**From:** Grant Zwiefelhofer <gzwiefelhofer@kapurinc.com>  
**Sent:** Wednesday, February 22, 2023 5:19 PM  
**To:** Michalets, Linda M - DNR  
**Cc:** James Bannantine  
**Subject:** RE: Cristo Rey Proposed Language  
**Attachments:** D.2 Site Layout Map.pdf

PROJECT:  
**CRISTO REY  
JESUIT HIGH  
SCHOOL**

LOCATION:  
1818 WEST  
NATIONAL AVE.  
MILWAUKEE, WI  
53204

SHEET:  
**SITE LAYOUT MAP**

SHEET NUMBER:  
**D.2**

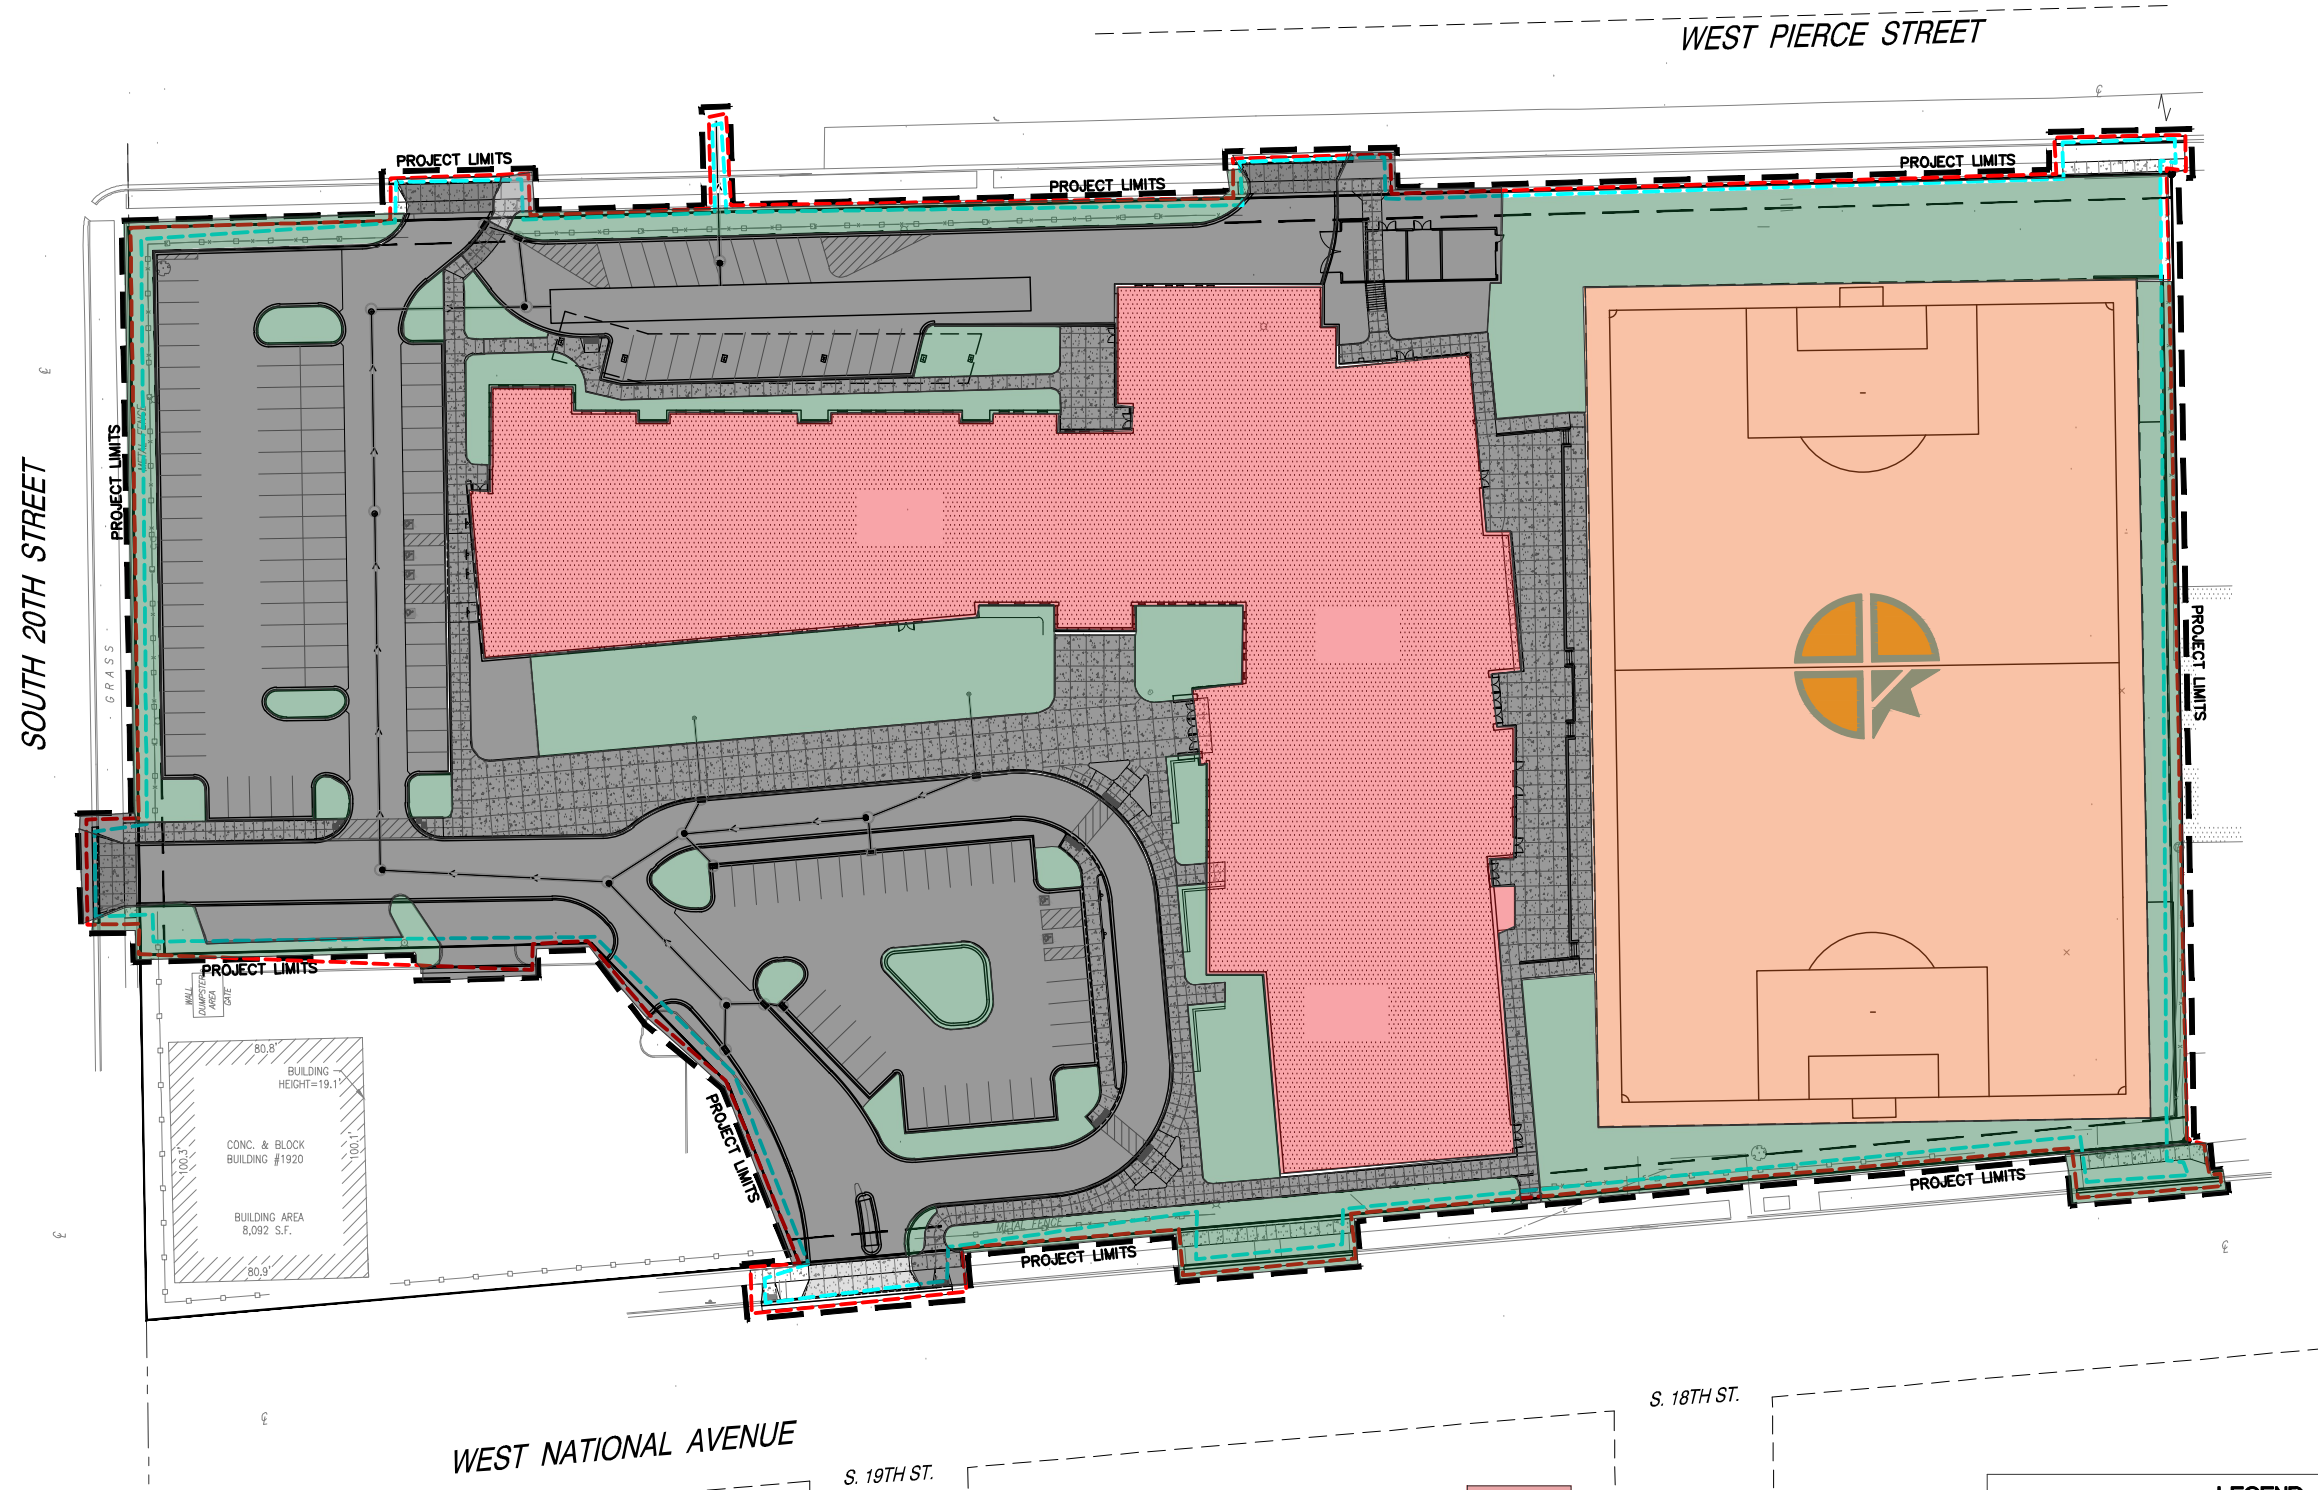
I received the revised SIR and am going to try to review it as soon as possible. With my first read of the report, I note that the cap maintenance plan figure (attached) does not include all the required information. Could you send me a revised figure for me to add to report as I finish my review?

Below is a description of what should be depicted on Figure D.2. when submitting the site for closure:

**D.2. Location map(s) which show(s):** (1) the feature that requires maintenance; (2) the location of the feature to be maintained - on and off the source property; (3) the extent of the structure or feature(s) to be maintained; (4) the extent and type of residual contamination; and (5) all other structures or features on the site;

The D.2. figure should identify the location of the different features that will be maintained, as shown in the example I sent you previously (attached).

That line is adequate for identifying the fill material, but one or more separate RCL lines are needed. The RCL line needs to be identified for what the contaminants are that it applies to, and must identify if it is for direct contact RCLs and/or groundwater pathway RCLs. I have attached an example of a D.2 figure for a site closed with fill material as the source (BRRTS 02-41-583268). Unfortunately, that closure packet is not yet uploaded to BRRTS. That site had PAHs and metals above RCLs. Is this helpful? I will look for another example to send you.

Attached is the D.2 Site Location figure you were looking for. Let me know if there is anything else you need.
